FIELD ADVISORY

FA#96-006
April 11, 1996

SUBJECT: Revised CMOS Microprocessor In LTR® 8600/40 Mobile Radios
Supersedes 8600/8640 information in FA#96-003

R115/R116 and R117 Locations In 8600 Mobile
Figure 1

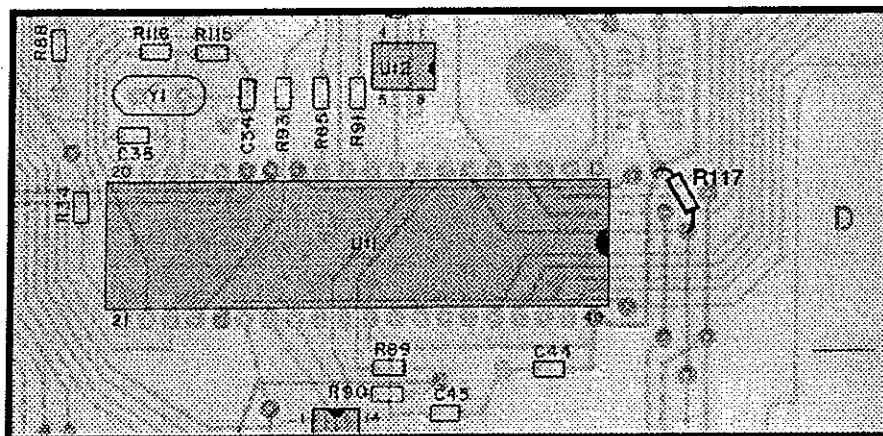
When replacing an HMOS microprocessor that has a part number of 023-9998-168 with a CMOS device, it is required that R115 and R116 on the audio logic board be removed. The two 100KΩ resistors are located directly adjacent to microprocessor crystal Y1. See the top side audio logic board layout in the 8640 service manual for the location of the resistors. The current 8600 radio service manual audio logic board layout does not show these resistors. Figure 1 below shows the location of the resistors in a partial view with relation to the microprocessor (U11) and Y1. These resistors are used in the microprocessor clock circuit and will only be present in units using the HMOS version of the 023-9998-168 device.

Add	R117	as a 569-0511-103
Change	Q4	to a 576-0001-300
Change	R34	to a 569-0115-104
Change	R71	to a 569-0115-683
Change	R79	to a 569-0115-472
Change	R80	to a 569-0115-104
Delete	R115	
Delete	R116

R117 is an axial leaded 10K Ω resistor. This resistor should be placed in existing holes near U11 as shown in Figure 1. The resistor is electrically connected between pins 6 and 40 of U11.
